A66 Northern Trans-Pennine Project TR010062

Application for a Non-Material Change to The A66 Northern Trans-Pennine Development Consent Order 2024

Application Statement

10 December 2025

Figure 2 – Comparison showing the Proposed Change overlaid on the Authorised Development

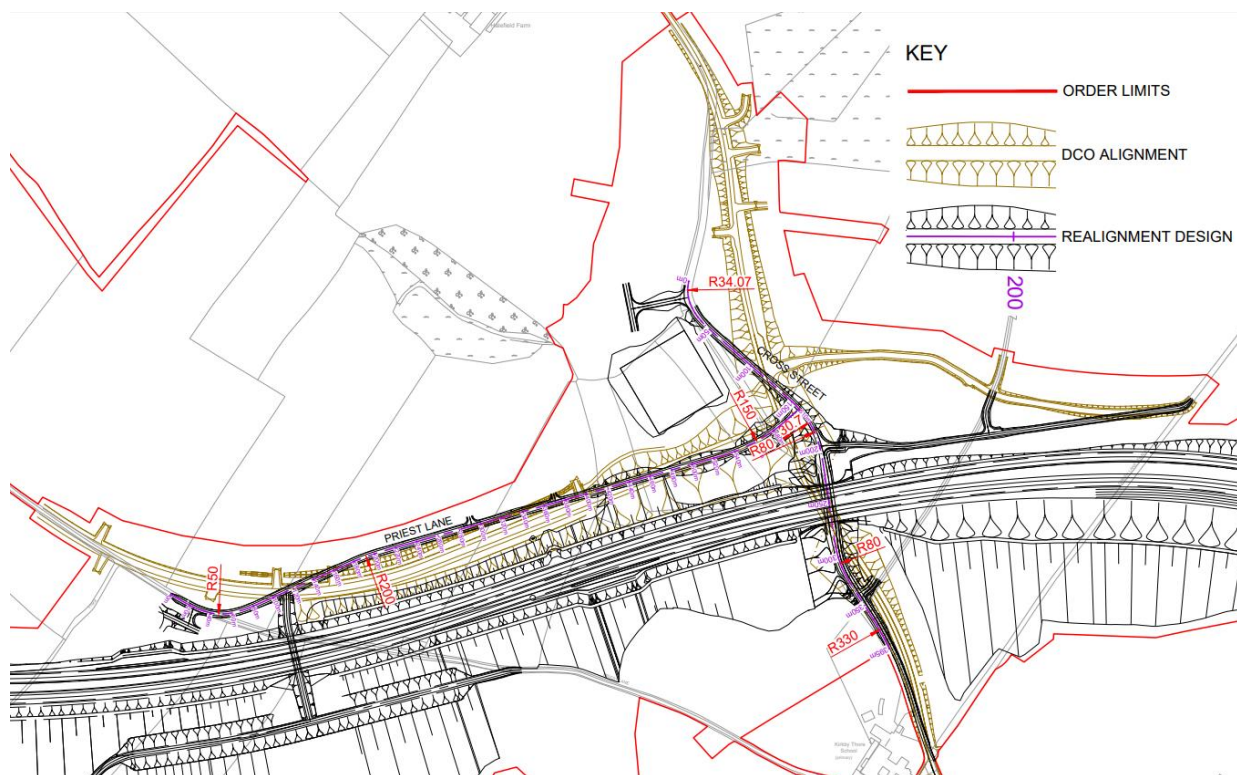
- 2.2.4. The Proposed Change comprises the realignment of the Cross Street overbridge, approaches and the connecting junctions and PMA. The lateral alignment of Cross Street would be adjusted by up to 30.7 metres beyond the current lateral LoD for the consented Work No. 0405-7. The LoD are currently 3 metres to the east of the centre of Cross Street and to the extent of the corresponding fine dashed green line as shown on the consented Works Plans to the west.

- 2.2.5. The Priest Lane junction with Cross Street would be relocated beyond the current lateral LoD for consented Work No.0405-6C which is 3 metres to the south of the centre of Priest Lane and to the extent of the corresponding fine dashed green line as shown on the consented Works Plans to the north.

- 2.2.6. The new Bridleway between the realigned Cross Street and Bridleway 336/018 would be relocated beyond the current LoD for the consented Work No. 0405-8 which is 3 metres to the north of the centre of Priest Lane and to the extent of the corresponding fine dashed green line as shown on the consented Works Plans to the south.

- 2.2.7. Proposed Change 1 (Cross Street) therefore comprises the realignment of the centreline for each of the consented Work Nos. 0405-7, 0405-6C and 0405-8. The current LoD (as stated above) would then apply to the realigned centrelines for those numbered works.

Figure 3 – Comparison showing the Proposed Change to the alignment of Green Lane overlaid on the Authorised Development

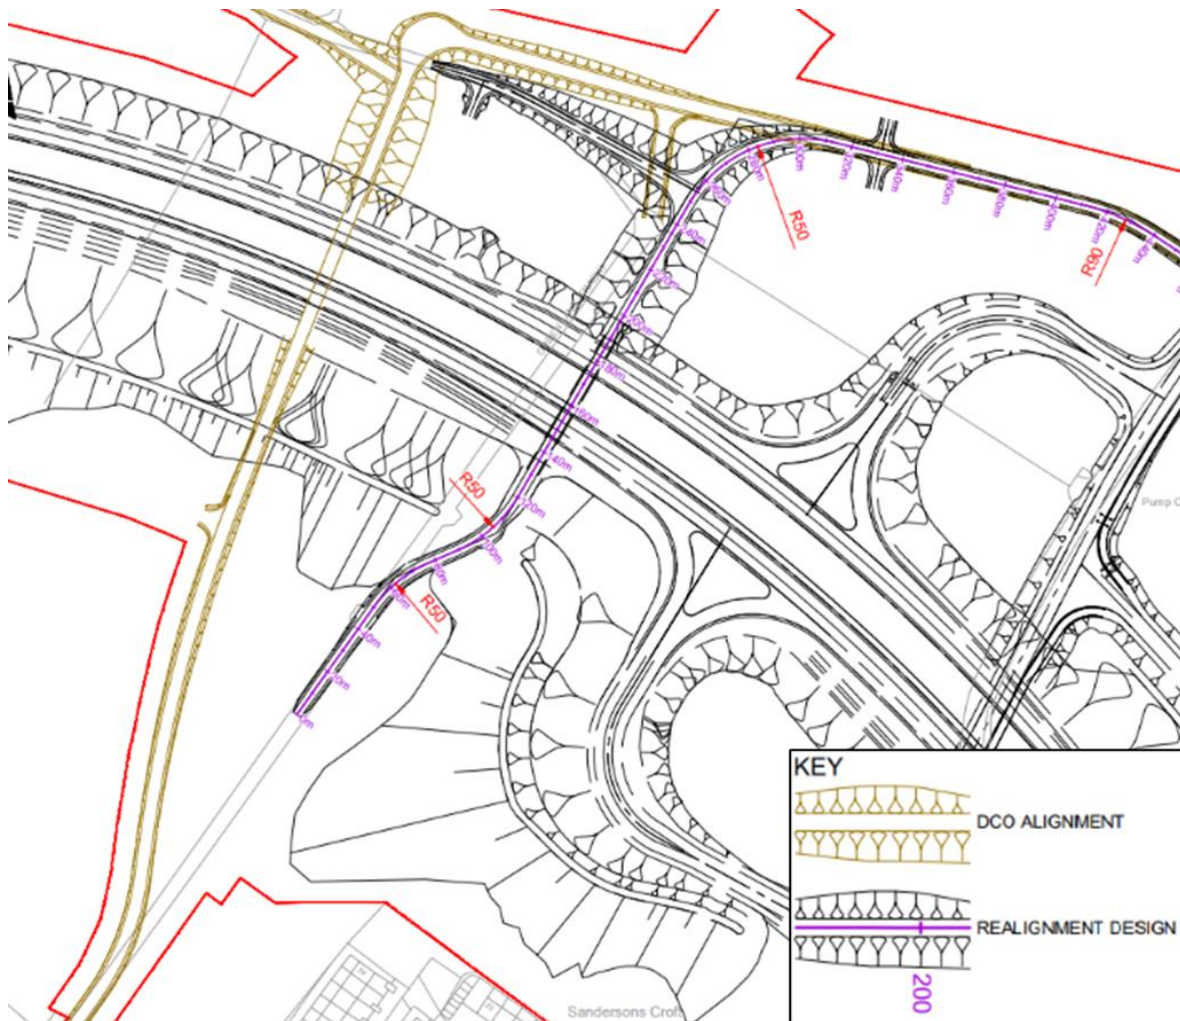
- 2.3.4. The Proposed Change comprises keeping the current alignment of Green Lane and constructing the new Green Lane overbridge on the existing alignment of Green Lane. The realignment compared to the work currently authorised by the Order would be beyond the current lateral LoD of the authorised Work No. 0405-9 which are 3 metres either side of the centreline.
- 2.3.5. Proposed Change 2 (Green Lane) therefore comprises the realignment of the centreline of the authorised Work No. 0405-9. The current LoD (as stated above) would then apply to the realigned centreline for this numbered work.

Figure 4 – Comparison showing the Proposed Change overlaid on the Authorised Development

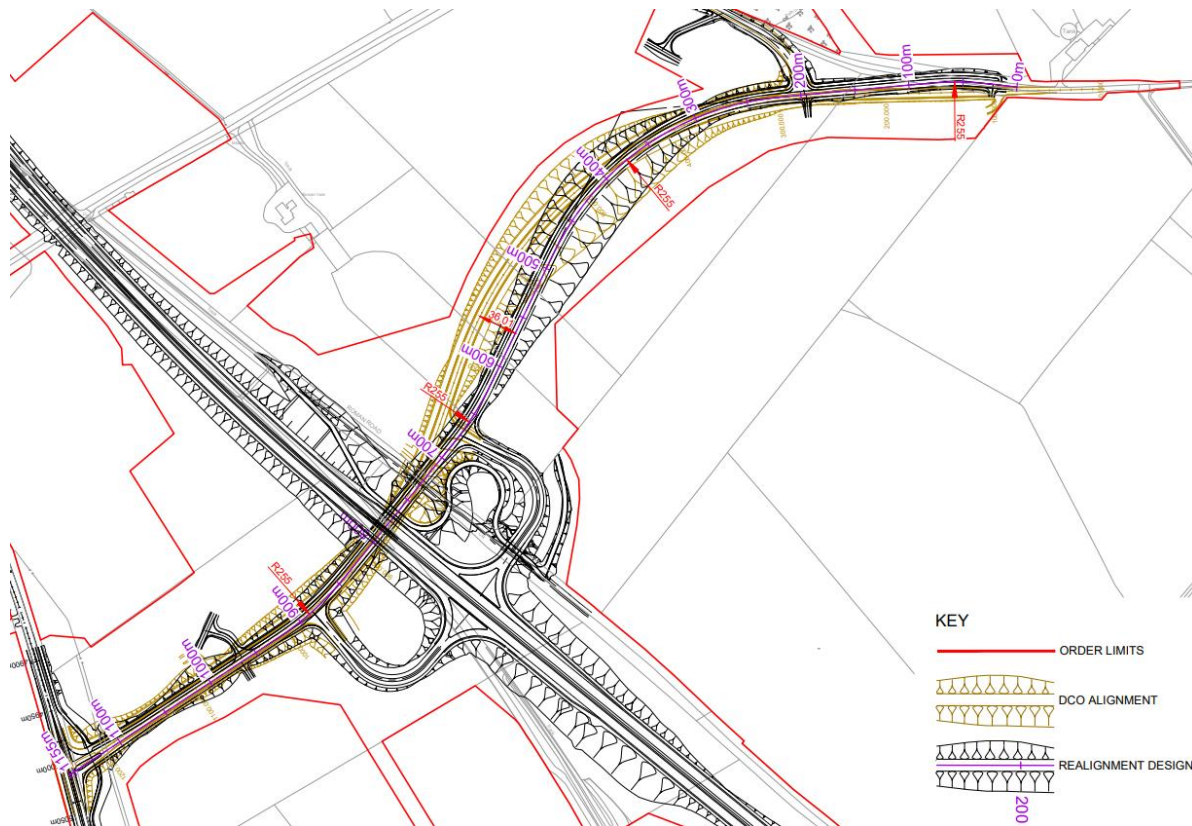
- 2.4.3. The Proposed Change comprises the realignment of Long Marton to reduce the span of the bridge, which would also reduce the amount of third party land required for its delivery. This realignment would also necessitate a reduction in the design speed to 85kph (50mph) which would be undertaken through a Traffic Regulation Order (TRO) in accordance with article 42 of the Order, separate to this Change Application.
- 2.4.4. The realigned design falls beyond the current lateral LoD of the authorised Work No. 0405-16 which are 3 metres either side of the centreline, the centre of the approved DCO road alignment.
- 2.4.5. Proposed Change 3 (Long Marton) therefore comprises the realignment of the centreline of Work No. 0405-16. The current LoD (as stated above) would then apply to the realigned centreline for this numbered work.

Figure 5 – Comparison showing the Proposed Change overlaid on the Authorised Development

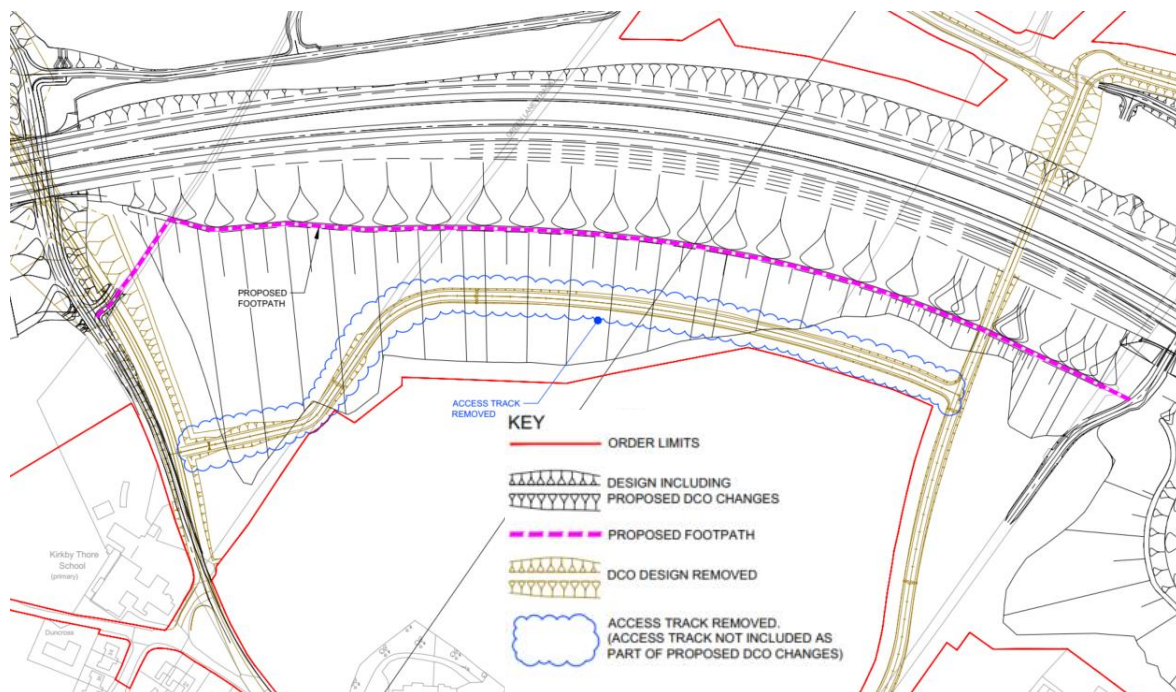
- 2.5.4. The Proposed Change comprises the removal (i.e. not constructing) of the approved access track between the realigned Cross Street and realigned Green Lane, and instead creating a new section of PRow (as shown by the pink dashed line in Figure 5 below) along the bottom of the southern embankment of the new A66 between the realigned Cross Street and Green Lane.
- 2.5.5. Proposed Change 4 (Access Track at Kirkby Thore) therefore requires the change of a provision for a public right of way and private means of access between Green Lane and Cross Street to a PRow to be shown on an updated version of Sheet 2 of the Rights of Way and Access Plans.

Figure 6 – Comparison showing the Proposed Change overlaid on the Authorised Development

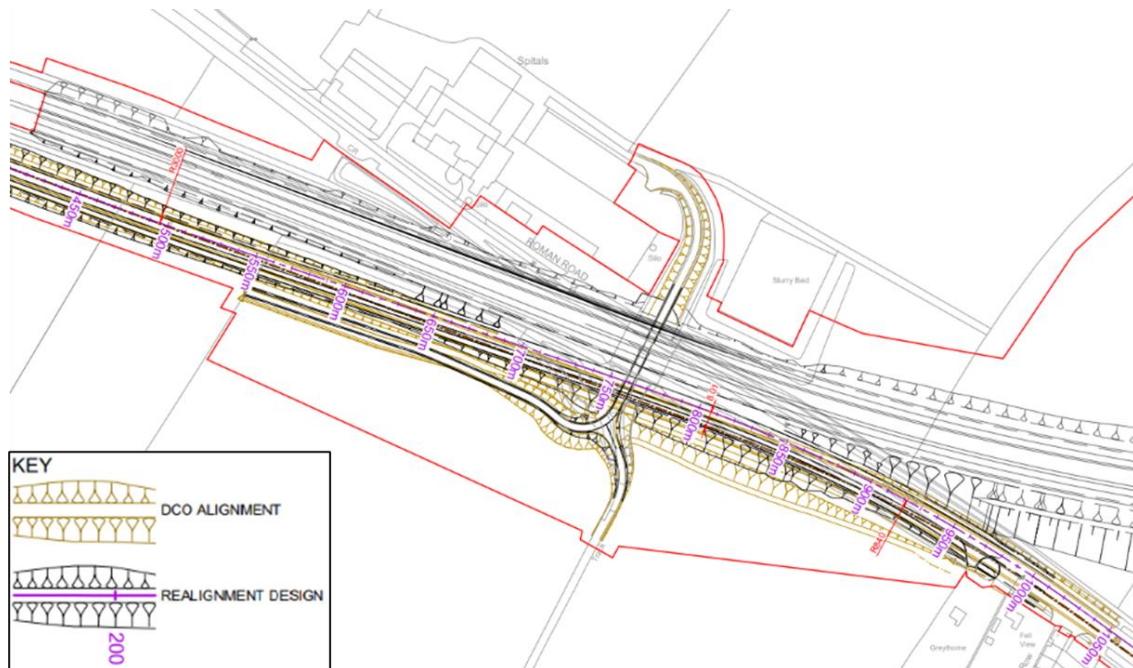
- 2.6.4. The Proposed Change is to the alignment of the new B6542, moving up to 8 metres closer to the new A66. This exceeds the lateral LoD for the authorised Work No. 0405-4A which is 3 metres either side of the centreline of the road approved in the DCO.
- 2.6.5. Proposed Change 5 (B6542 and Spitals Farm access) therefore comprises the realignment of the centreline for the authorised Work No. 0405-4A. The current LoD (as stated above) would then apply to the realigned centreline for that numbered work. This change would also involve a change to the replacement private means of access to Spitals Farm, insofar as the width of the underpass (beneath the de-trunked A66 / new B6542 and the new A66) would be reduced.

Figure 7 – Location of new Work No. 0102-1D-A

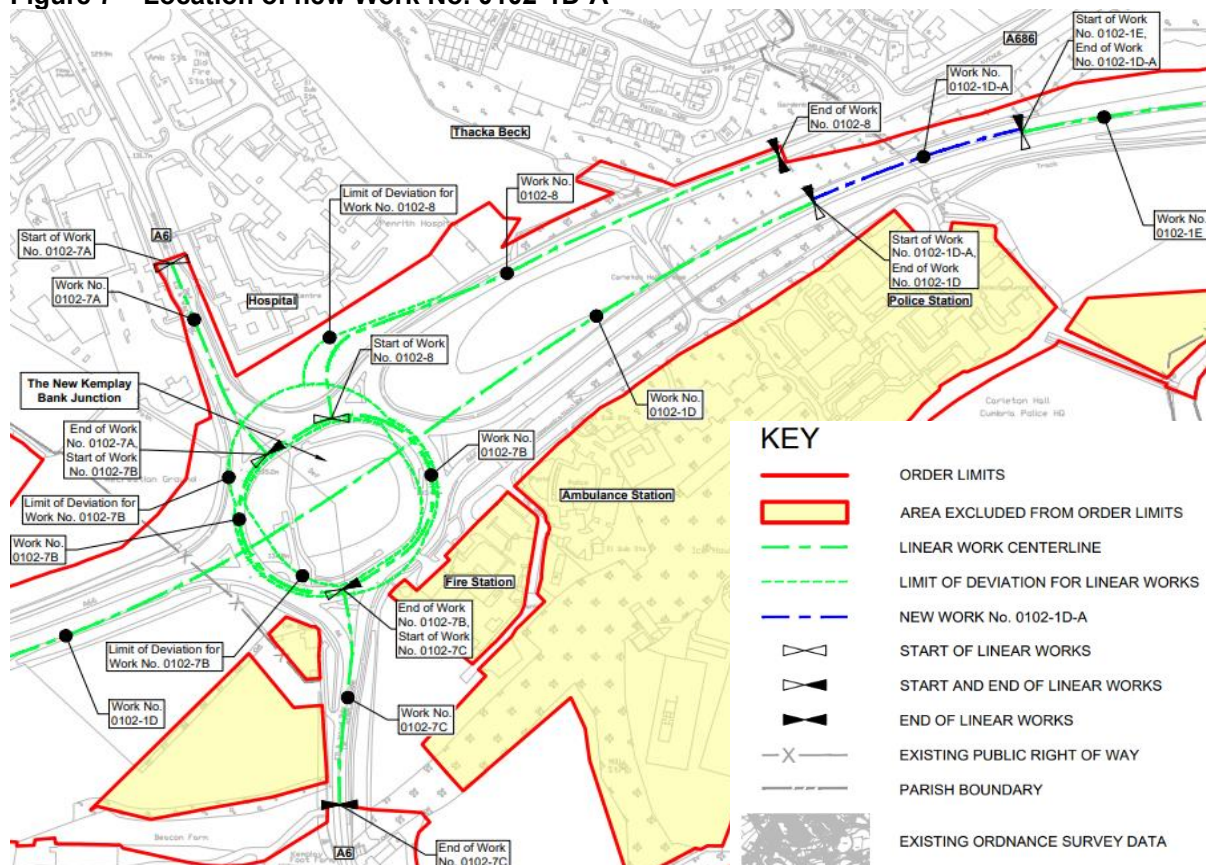
- 2.7.4. The Proposed Change is an amendment to a section of the centreline of Work No. 0102-1E. At the start of Work No 0102-1E to Chainage 11+400, the centreline would be re-located 2.5 metres to the north of its current location. The new section would be given a new Work Number and Work Number description under 0102-1D-A. The standard LoD for linear works (as set out in article 7 of the Order) would apply to the new Work No. 0102-1D-A.

Figure 8 – Comparison showing the Proposed Change overlaid on the Authorised Development

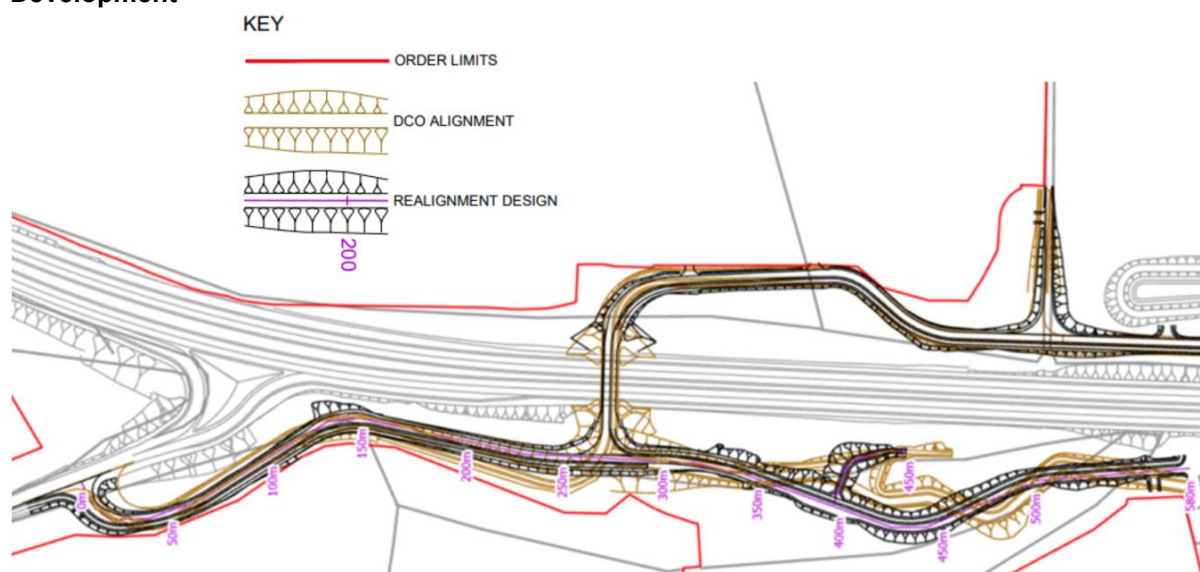
for Work No. 03-7A, which is 3 metres either side of the centreline. Proposed Change 7 therefore includes a partial realignment of the centreline for Work No. 03-7A, to which the standard 3 metre lateral LoD (as set out in article 7 of the Order) would subsequently apply.

- 2.8.8. Amendments of the same nature are also proposed to the alignment of the centreline of Work Nos. 03-7B, 03-9A and 03-9B. The proposed realignments of these combined PMAs and cycle tracks extend beyond the LoD for each of the relevant numbered works. The LoD for these linear works (as set out in article 7 of the Order) would continue to apply to their realigned centrelines.

Figure 9 - Comparison showing the Proposed Change overlaid on the Authorised Development

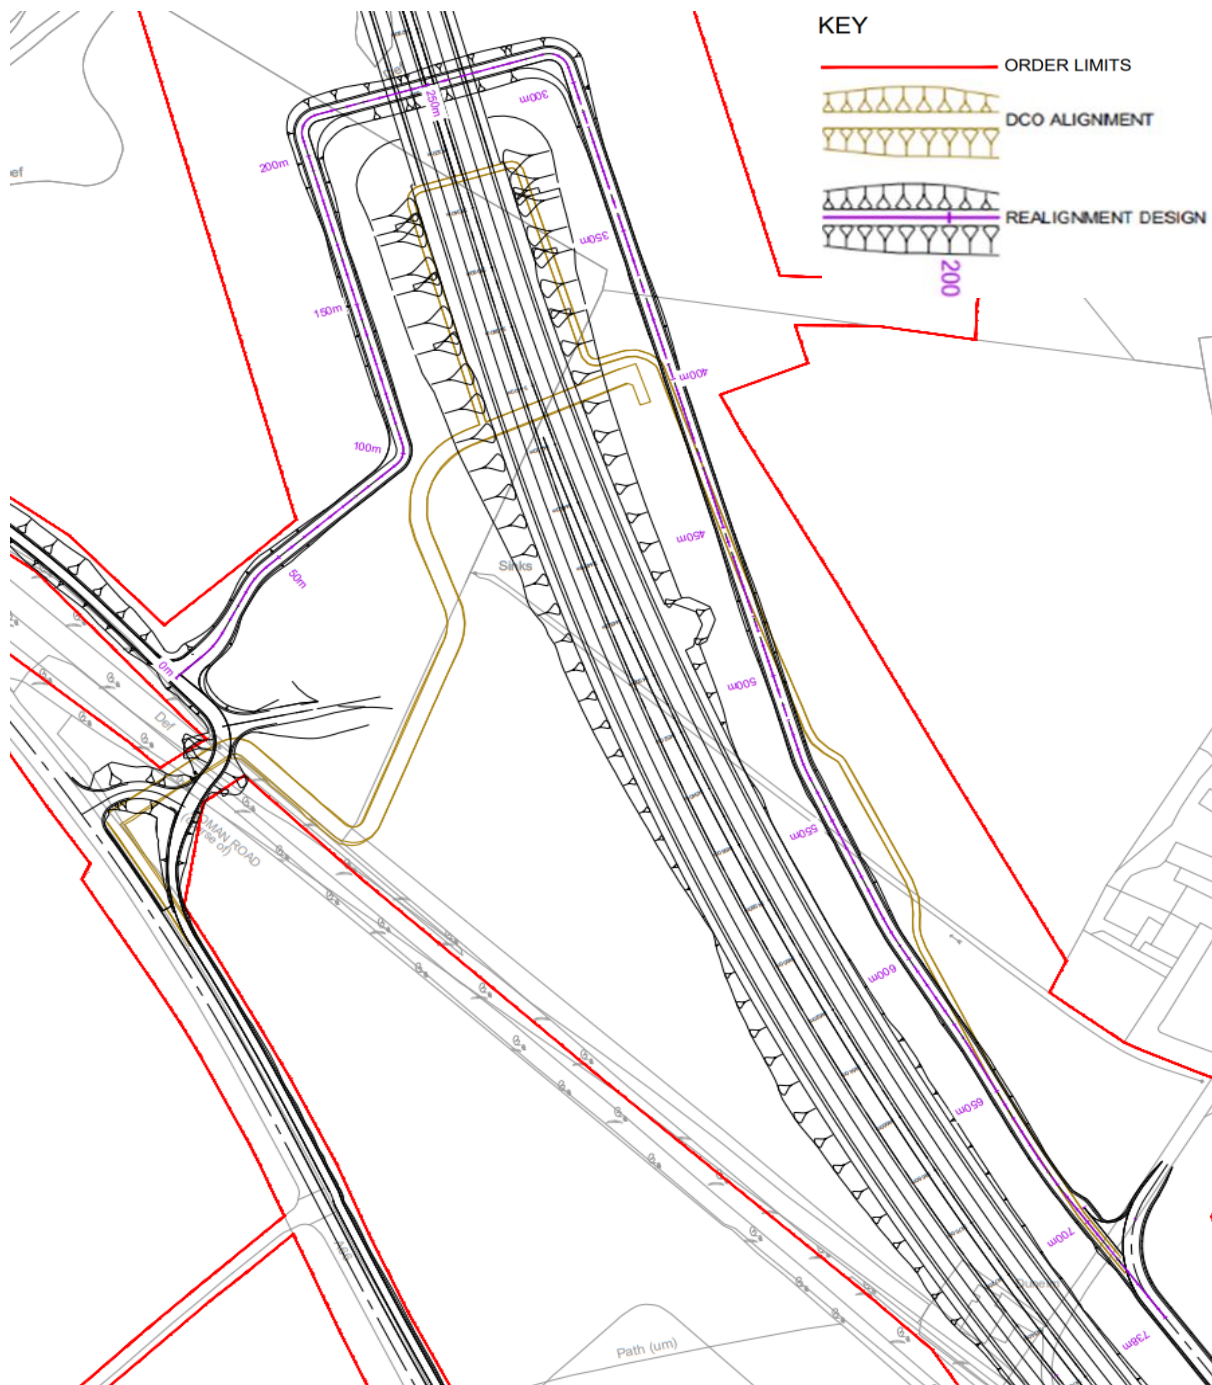
- 2.9.4. The Proposed Change comprises realigning the new footpath and private means of access approximately 20 metres to the northwest of its current authorised location. Such realignment is required in consequence of the shortening of the Trout Beck viaduct, which is pursuant to a detailed design change. The proposed re-alignment of the footpath and private means of access would exceed the current lateral LoD for Work No.0405-14, which is 3 metres to the north and south of the centreline of this numbered work.

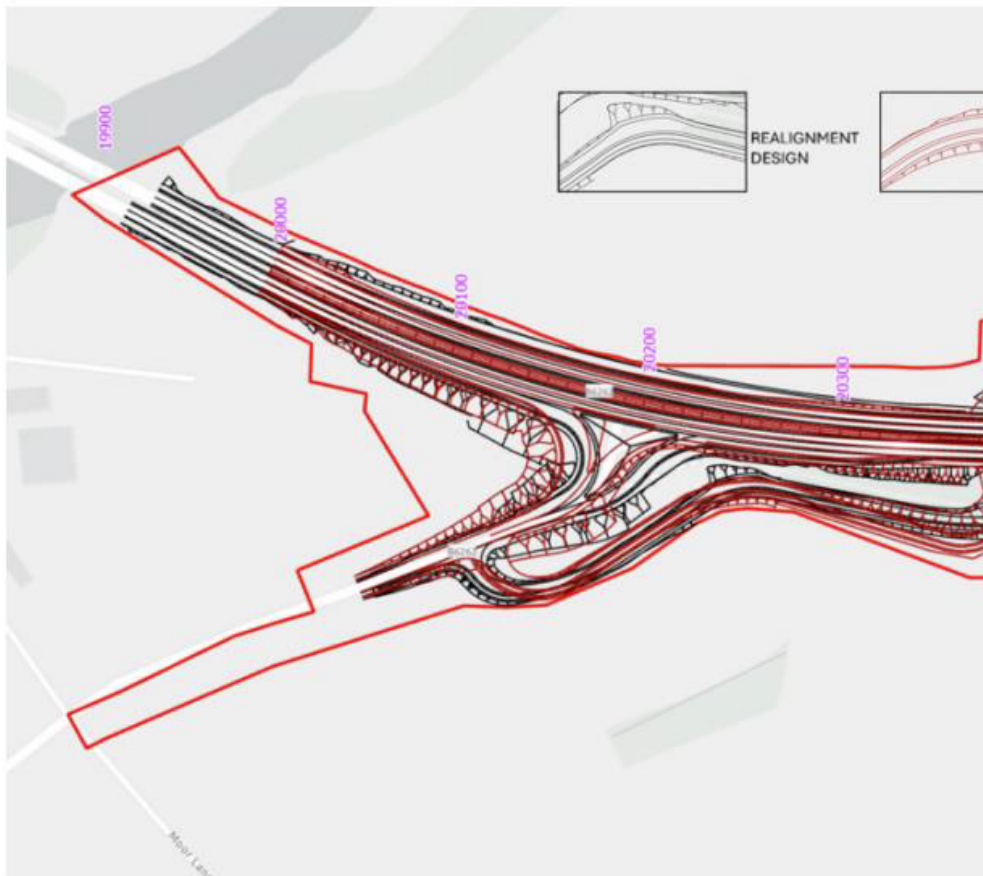
Please see below sketch showing the proposed alignment differences for Change 7, and a description of the change.

Description of the proposed change

- Realign the PMA junction with the B6262
- Realign the PMA South of the A66 between Ch 80-140 & Ch 220-300
- Realign the PMA North of the A66 between Ch 80-100 & Ch 475-500
- Realign the PMA to Llama Karma Kafe
